# ROLLING MEADOWS-BULL HILL CHANNEL & FLOODPLAIN

## 60% DESIGN GEC PLANS

## MODIFICATION GRADING AND EROSION CONTROL PLAN MARCH 2023

MATRIX PROJECT No. 21.1129.009

**PLAN AND PROFILE**  
STA. 19+00 - 32+00

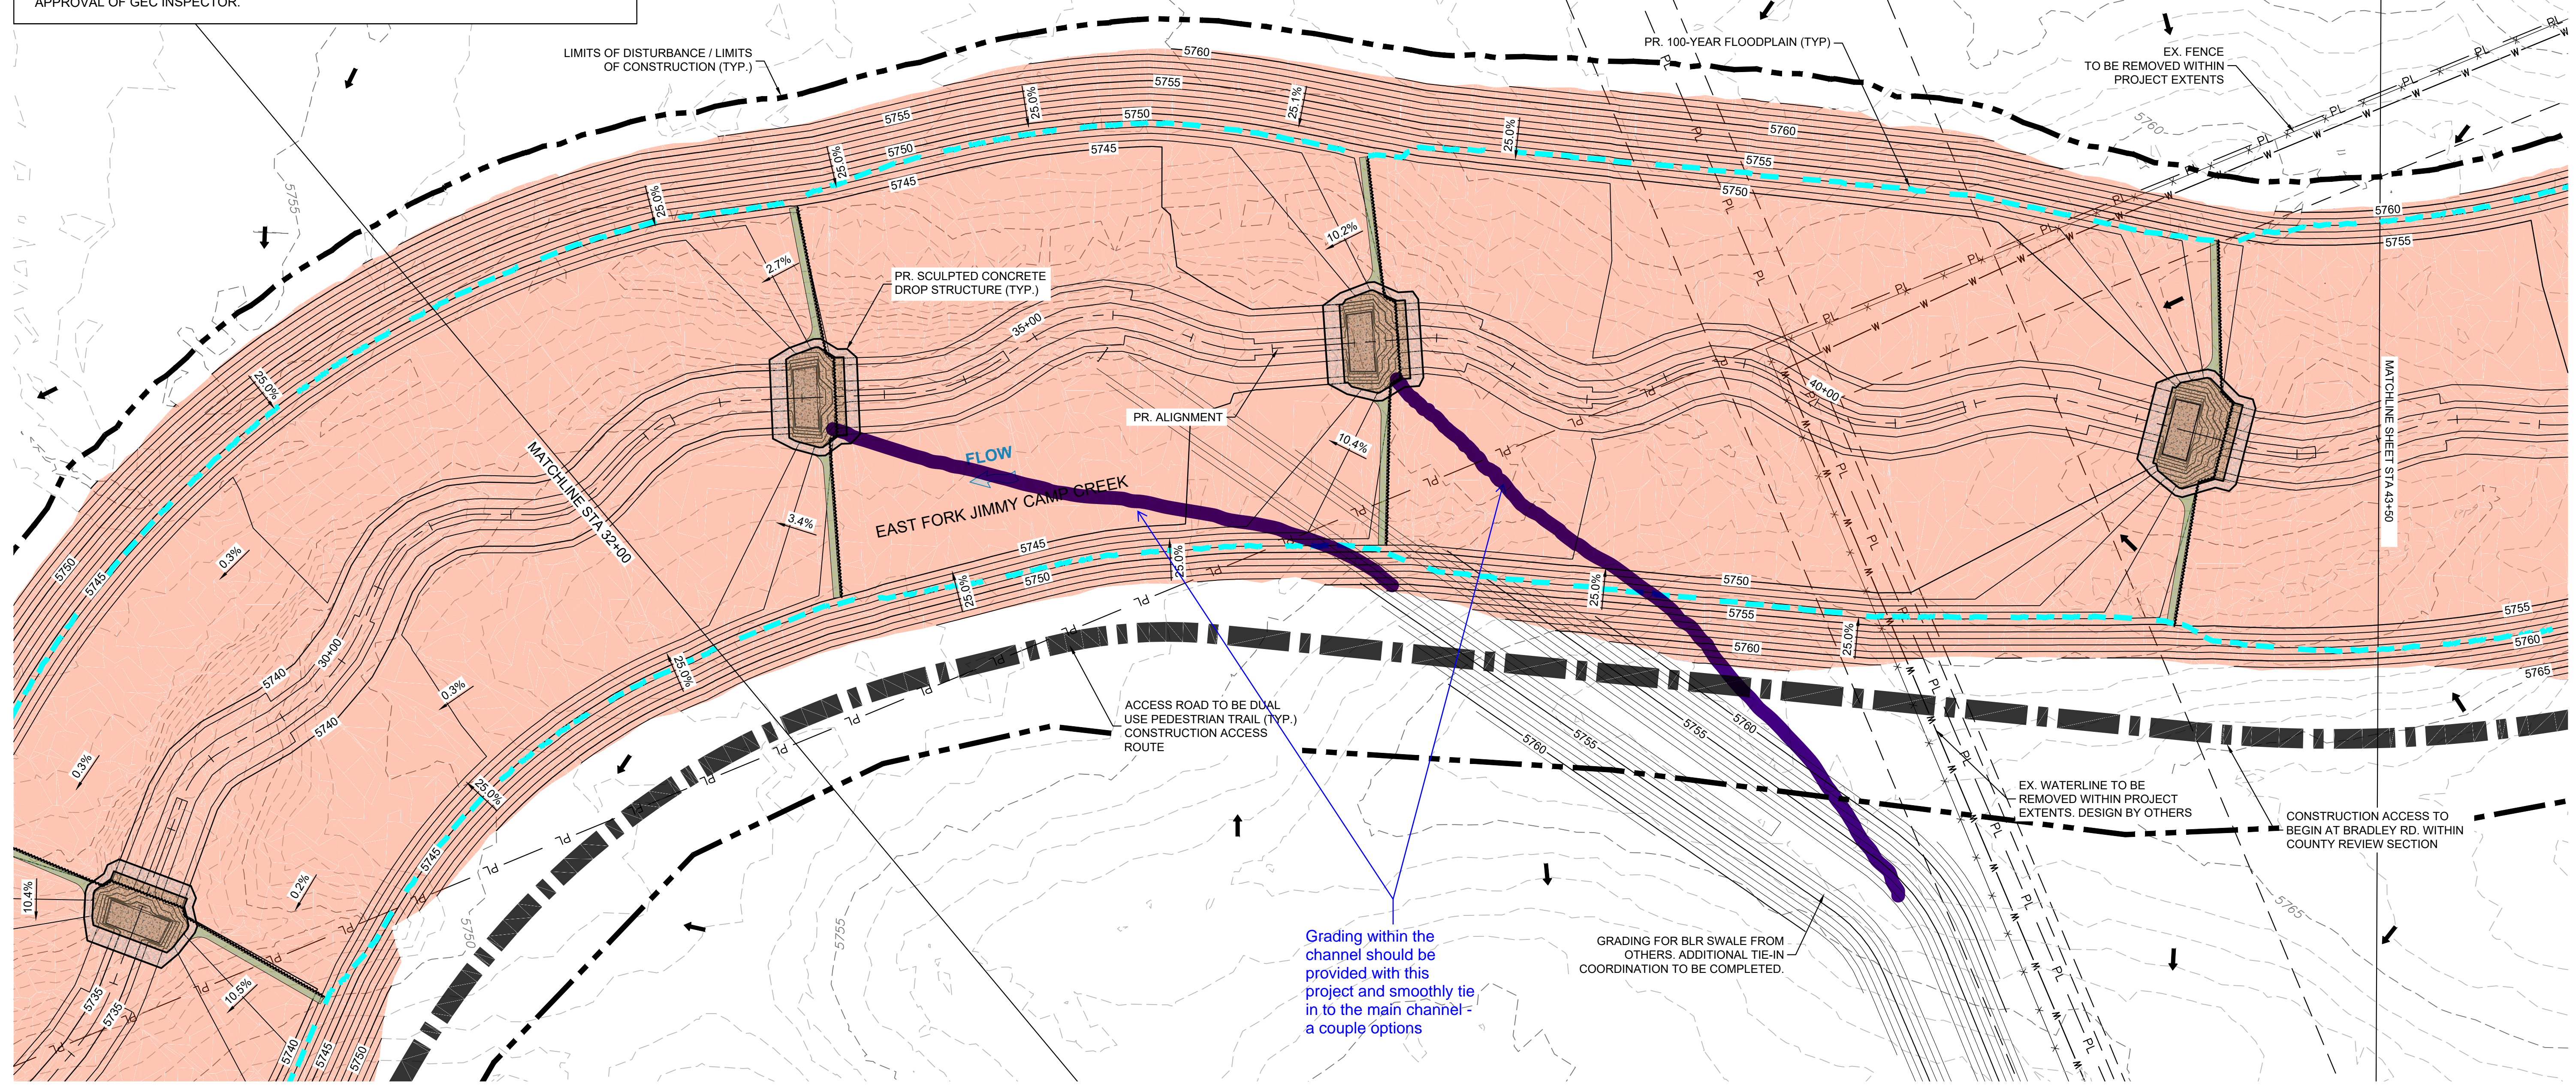
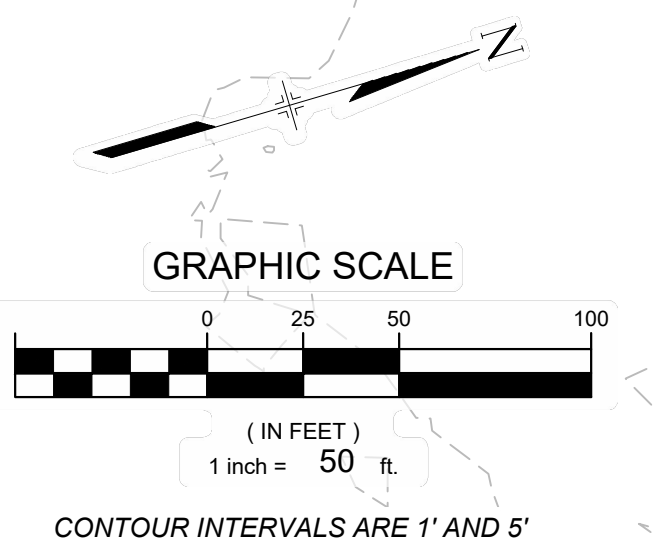
Unresolved. Label all adjacent city/town/jurisdictional boundaries, subdivision names, and property parcel numbers.  
Label all proposed temporary construction BMPs by phase of implementation (initial, interim, final).  
add correct sheet number to all matchlines or remove callout to sheets for all matchlines (typ.)

Include a key map that shows overall location and limits of each stream section for each sheet

PLAN AND PROFILE  
STA. 73+02 - 88+26

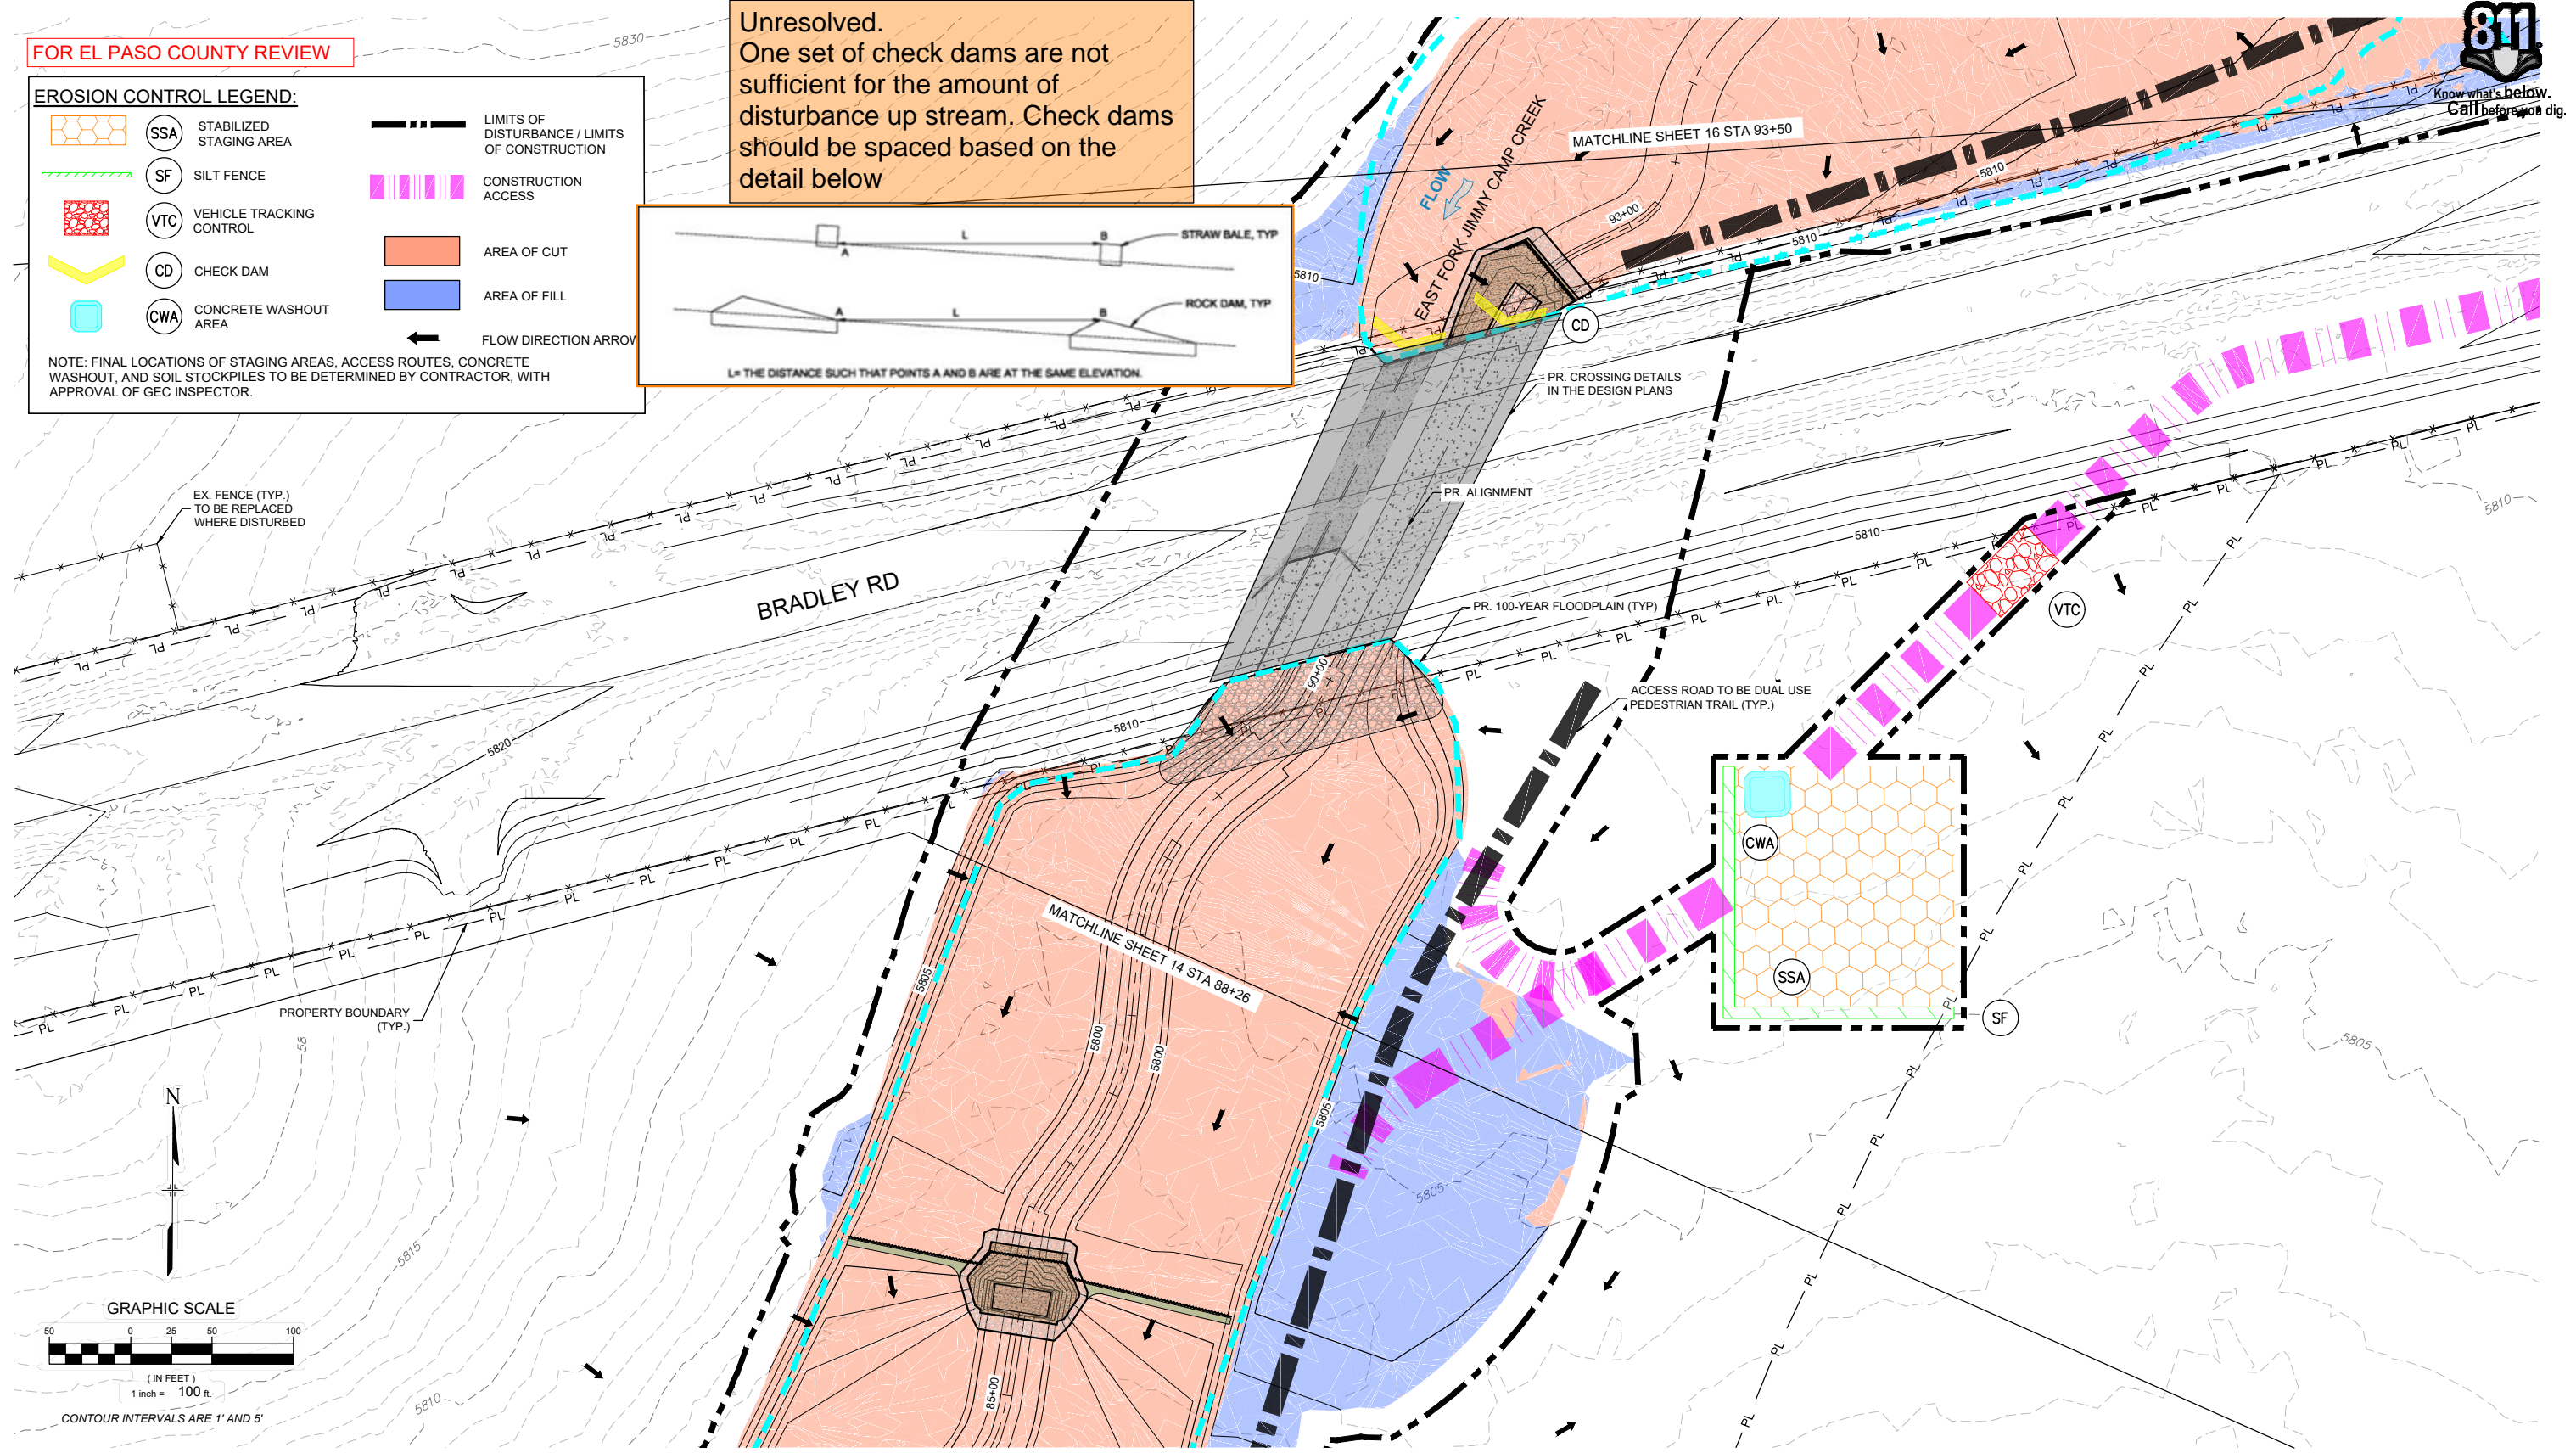
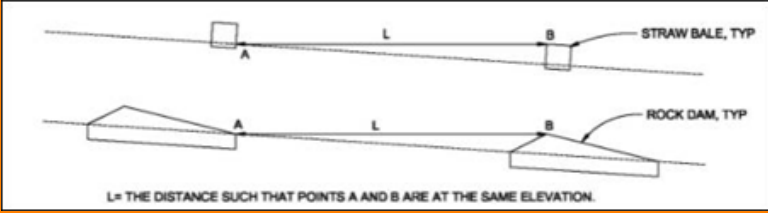
Unresolved.  
One set of check dams are not sufficient for the amount of disturbance up stream. Check dams should be spaced based on the detail below

PLAN AND PROFILE  
STA. 88+26 - 93+50

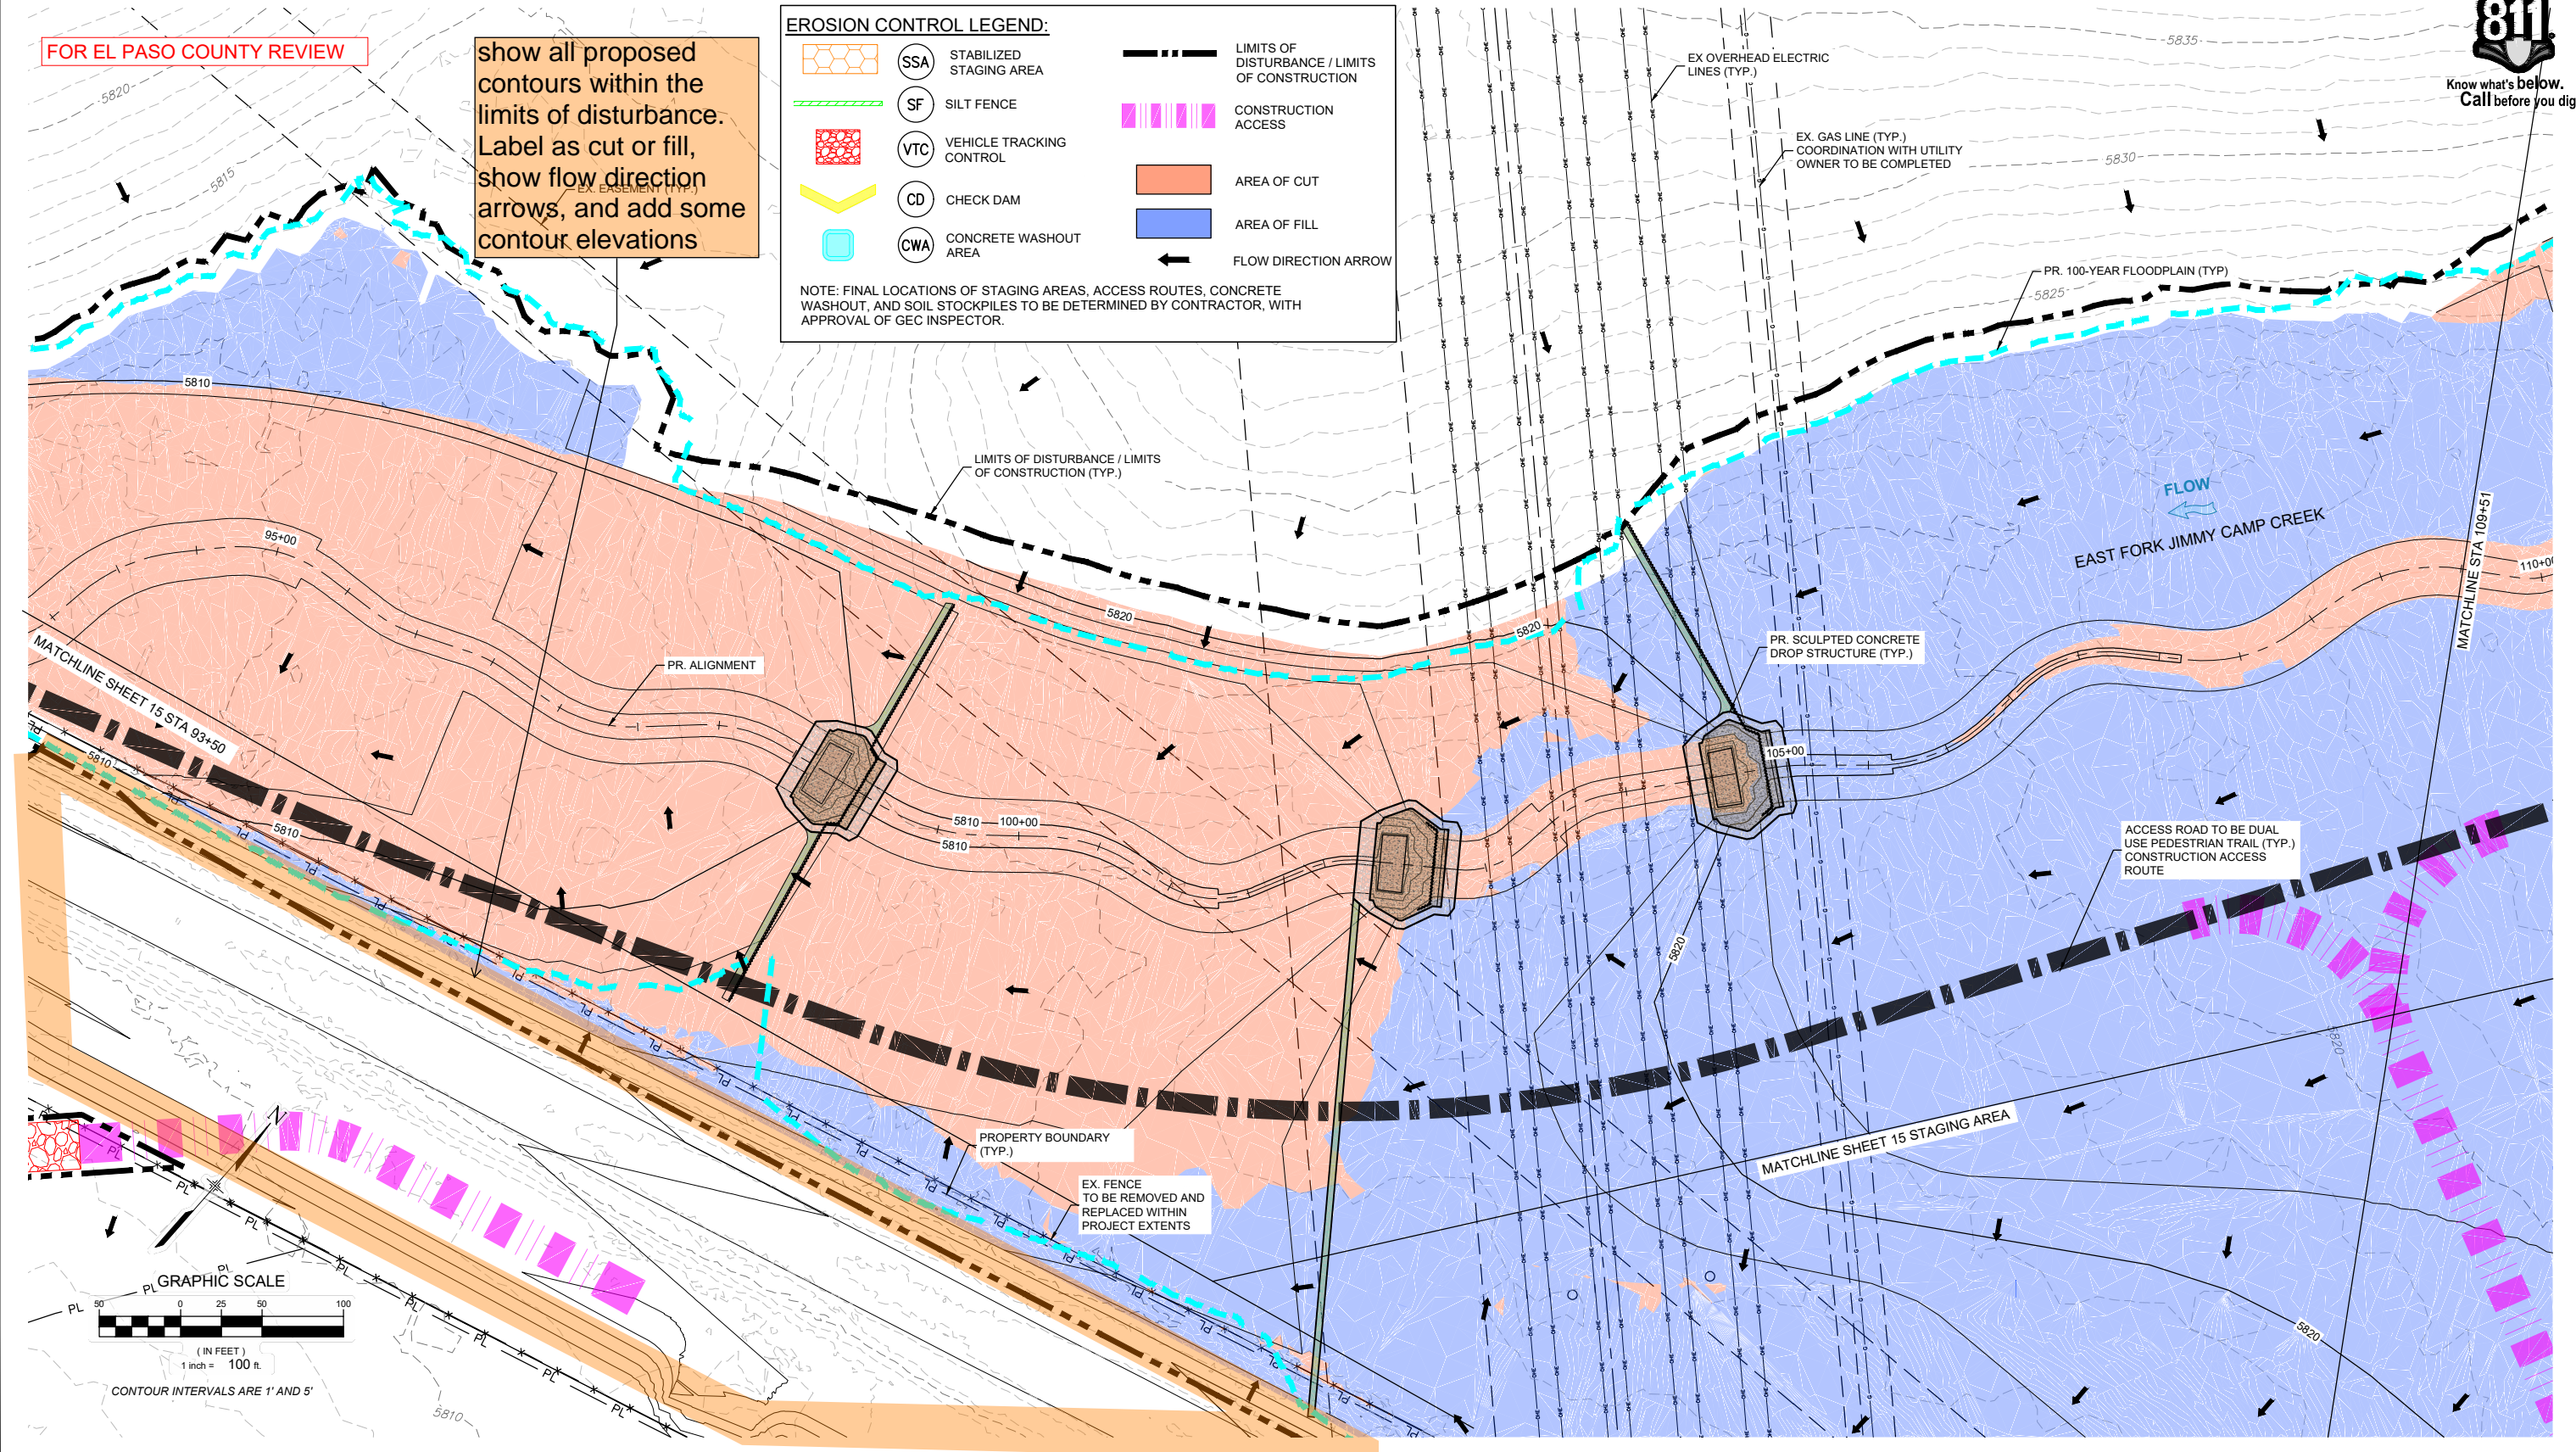
show all proposed contours within the limits of disturbance. Label as cut or fill, show flow direction arrows, and add some contour elevations
